CITY OF OREGON CITY HISTORIC REVIEW BOARD AGENDA

2. GLUA-21-00001/ HR 21-00001 through 21-00005: Historic Review for Canemah Cottages in the Canemah National Register Historic District.

Staff Report

To: Historic Review Board
From: Planner Kelly Reid

Original HRB Application - Site Plan

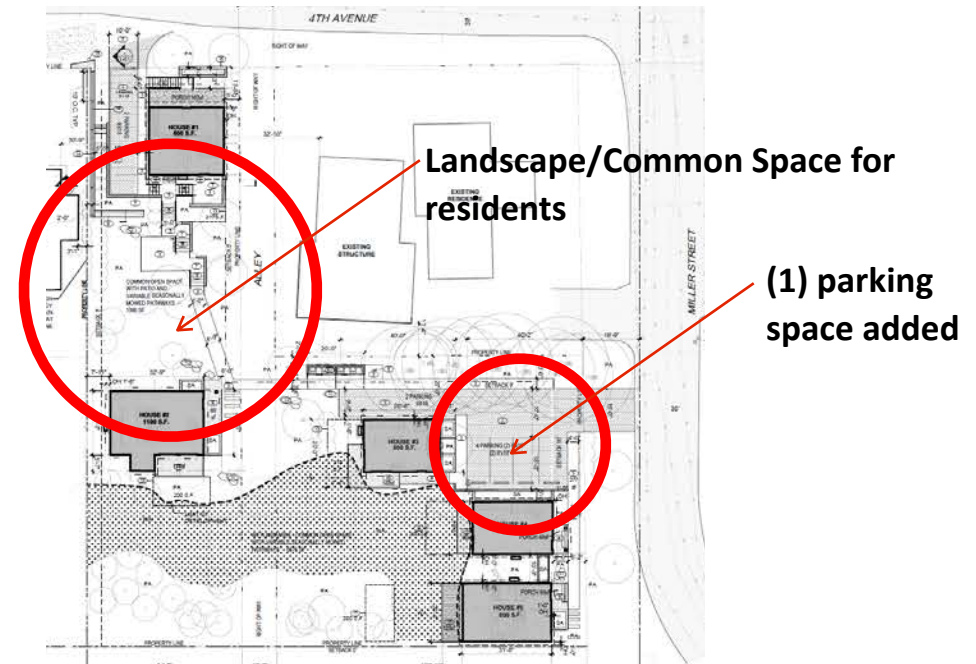
Changes from HRB Approval	Compatibility Proposed Mitigation
House 2 Removed	Per HRB COA's
Parking Area removed behind house 1. One space added by house 4.	Changed due to reduced parking and to minimize grading impact; Compatible w/Historic District.

Photo 1

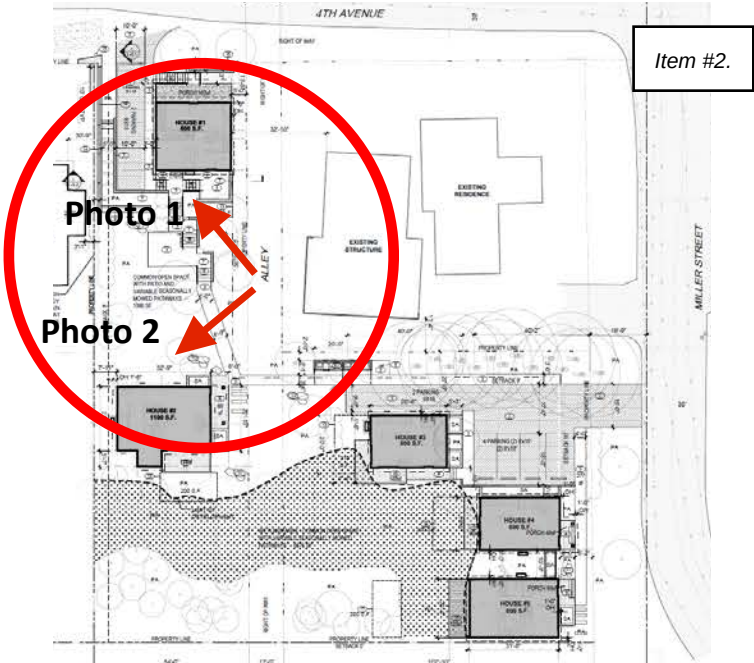
Changes from HRB Approval	Reason for Change / Compatibility Proposed Mitigation
Original House 2 removed	Per HRB COA's
Parking Area removed behind house 1. One space added by house 4.	Changed due to reduced parking and to minimize grading impact. At or near original topography. Compatible w/Historic District.

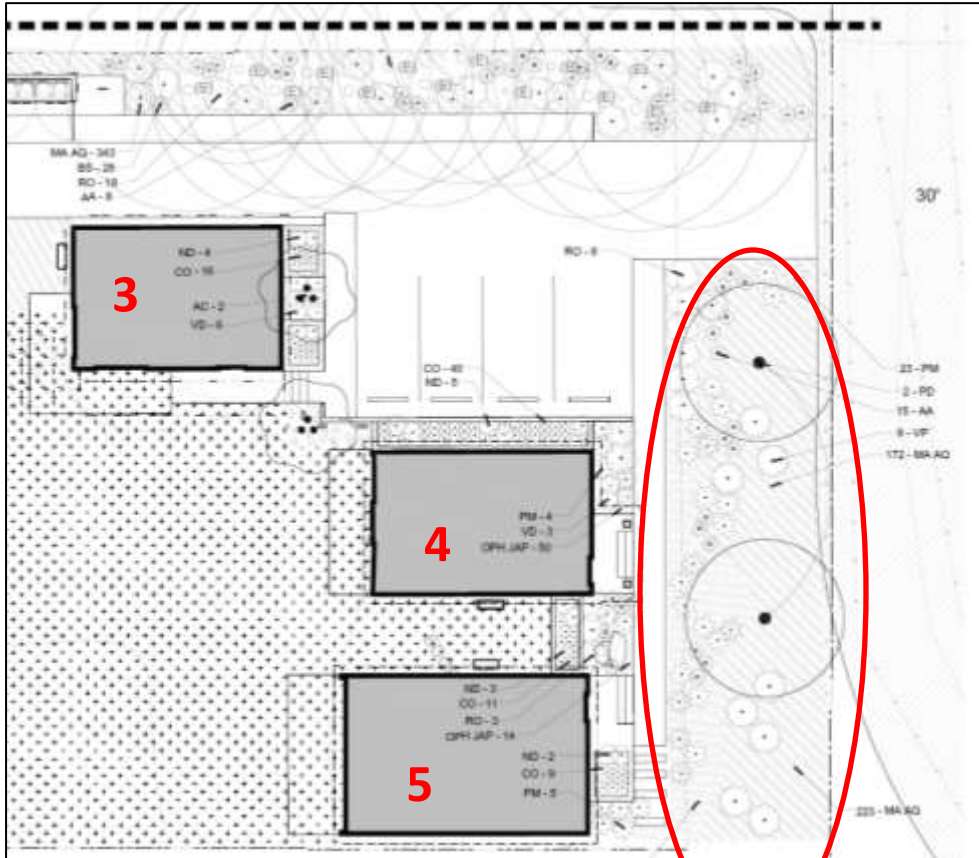
The applicant has opined that the textured hardieplank siding meets the city's guidelines, and has not proposed any possible actions that would mitigate for the siding material. For at least the past 15 years, the Board has consistently allowed only smooth hardieplank to mitigate for the use of non-wood siding material for new construction projects. The guidelines do not specifically prohibit textured hardieplank siding, but previous Boards have found that the textured product did not meet the guideline to use materials which have the appearance of horizontal wood siding. Last year, the Board required an HRB-approved project on Center Street to replace textured hardieplank siding with smooth, when textured siding was used by mistake. Board members noted that the waste caused by such a change was unfortunate but that the applicant should be held to the condition of approval. In the case of the Canemah Cottages, the HRB might find that given the setback, landscaping, and the small size of each residence, it might make sense to allow textured hardieplank as it would not be visible from the street and therefore not detract from the Historic District. The development project on Center Street was a commercial office building, built right up to the sidewalk and on a more visible thoroughfare.

If the HRB finds that the textured hardieplank siding is acceptable, the Board should adopt findings that are very context-specific and would not necessarily lead to an allowance for this siding for future development projects.

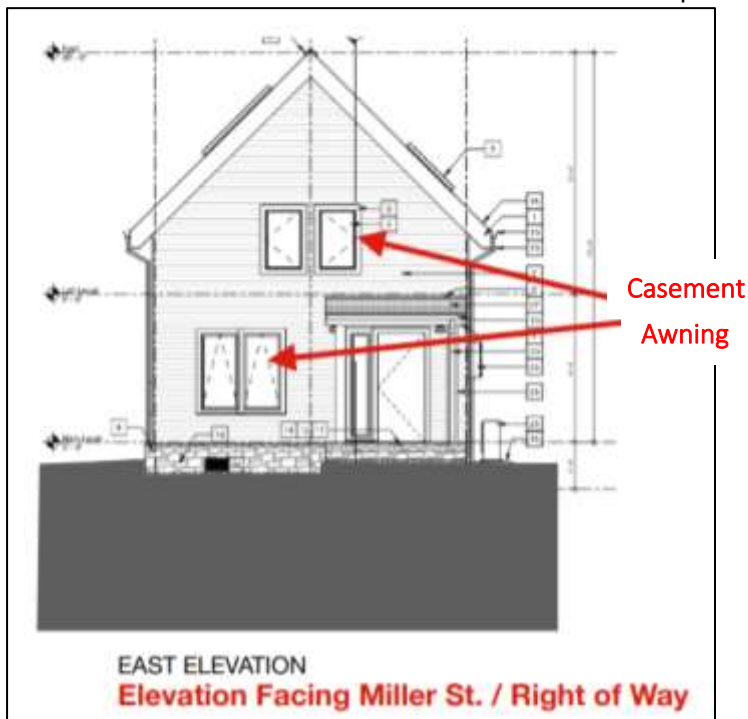
Staff Analysis and Recommendation: The member siding, thickness, and shadowline of painted wood windows is not clearly defined in the guidelines. Because they are casement style windows, the upper and lower portions have the same plane and do not create the shadowline effect of a single or double-hung window. The awning windows also lack the shadowline effect.

A key dimension for painted wood windows is window sill depth. The applicant states that all windows are recessed 1.5" from face of trim, but did not provide any other information comparing this to painted wood windows or demonstrating that this dimension meets the condition of approval. A historic, wood, double-hung window would likely have a greater sill depth, and the Board may or may not find that the 1.5" recessed dimension is acceptable for these windows. If the board requires that the windows be modified in any way, staff recommends that the board be very specific about what window dimensions would be acceptable.

As is the case with respect to the siding, these structures are significantly setback from the street such that the shadowline may not be visible. The proposed landscaping may shield some of the buildings from view. However, the Guidelines are fairly clear in requiring shadowlines that would match a historic wood window. Staff recommends that either (1) the awning windows should be replaced with windows with shadowlines that would match historic windows or (2) additional landscaping is installed and thicker outside window trim be added to increase the depth and shadowline."

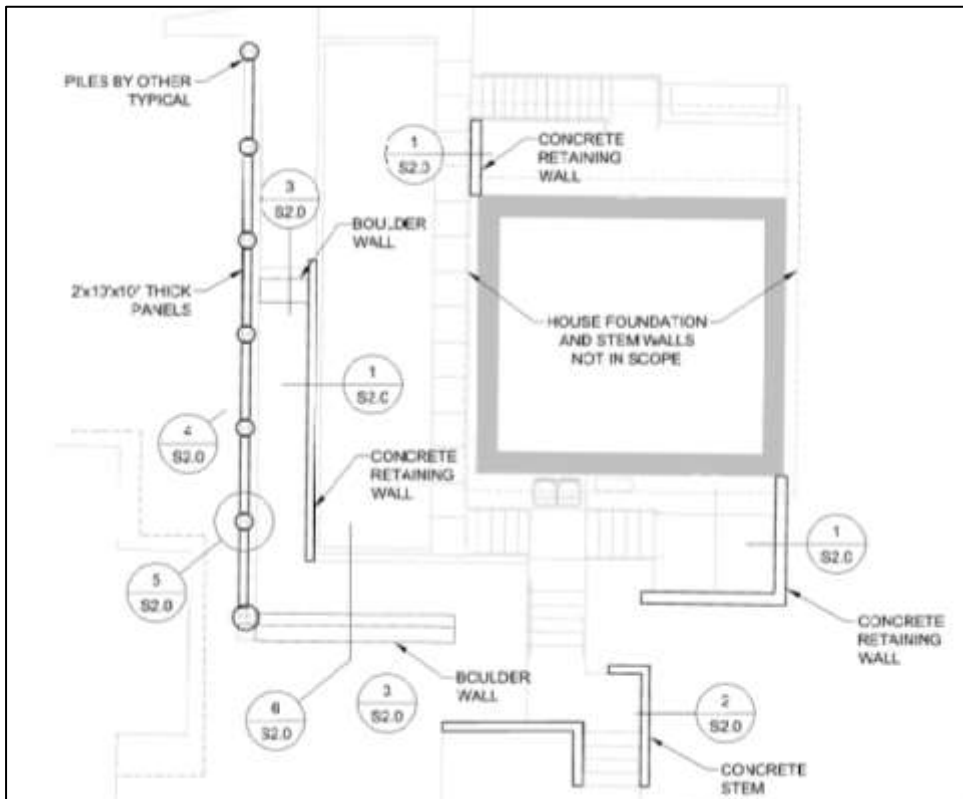
The skylights that have been installed are rectangular in shape with flat glass. They are placed on side-oriented roof slopes but are visible from the right of way, in violation of the condition. The skylight on House #2 does face 4th Avenue but is setback considerably from 4th Avenue, near the rear of the property. The skylight on House #2 will be at least partially obscured by trees planted on site. The skylights on House #5 are mostly obscured by vegetation, especially during the summer. House #4 blocks the view of the north facing skylights on House #5. Staff recommends that the skylights on House #2 and House #5 be approved.

While the skylights on House #4 do not meet the original condition of approval, staff advises that the skylights might be found to be appropriate due to their low profile, reasonable size, and location on side-oriented roofs. The use of skylights is a modern design and can be found to be compatible under these circumstances, especially on a structure with modest massing and height. There do not appear to be any possible actions that would mitigate for the visibility of these skylights.

Retaining wall next to House #1, at end of driveway

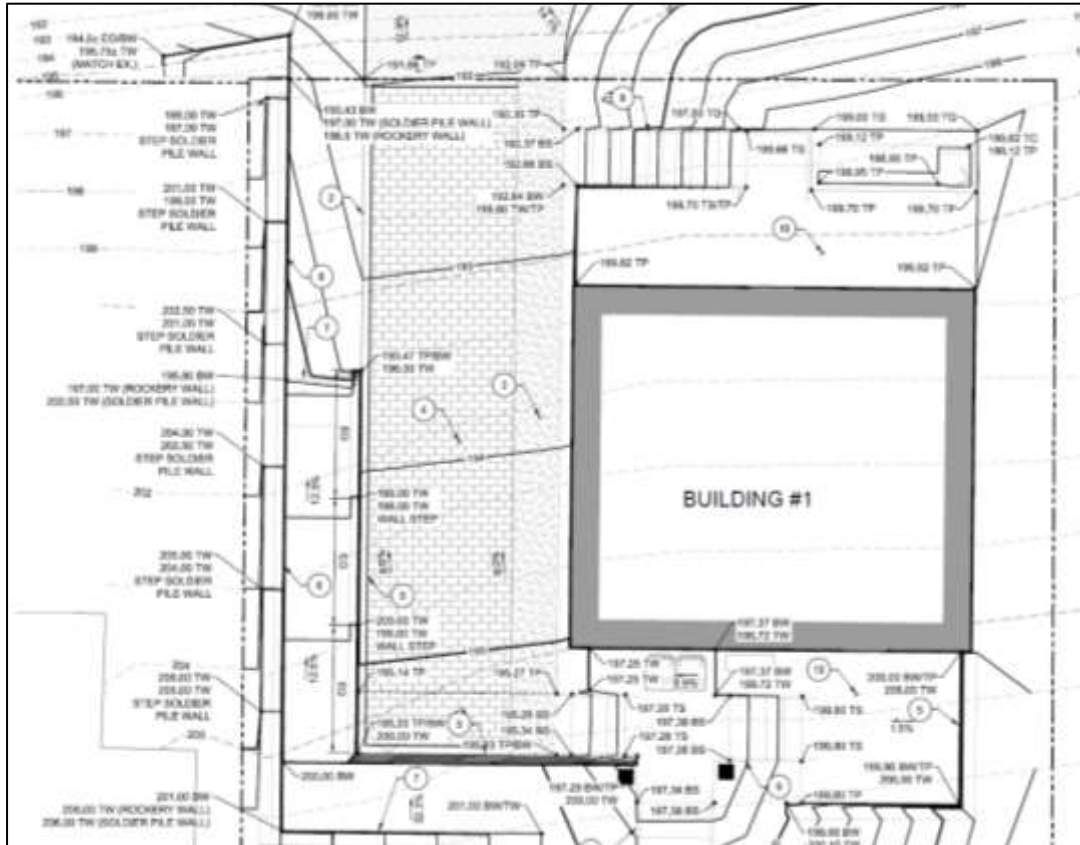
The design guidelines do not contain a specific height limit but rather call for minimization of retaining walls. The wall behind House #1 is in the rear yard and can be up to 6 feet in height based on general city standards. If the wall will end up being taller than 3.5 feet and the HRB finds that the height is not acceptable, the applicant could be required to add another wall to terrace the slope. Staff does not recommend any conditions of approval given that the wall is in the rear yard and proposed to be planted with vine coverage.
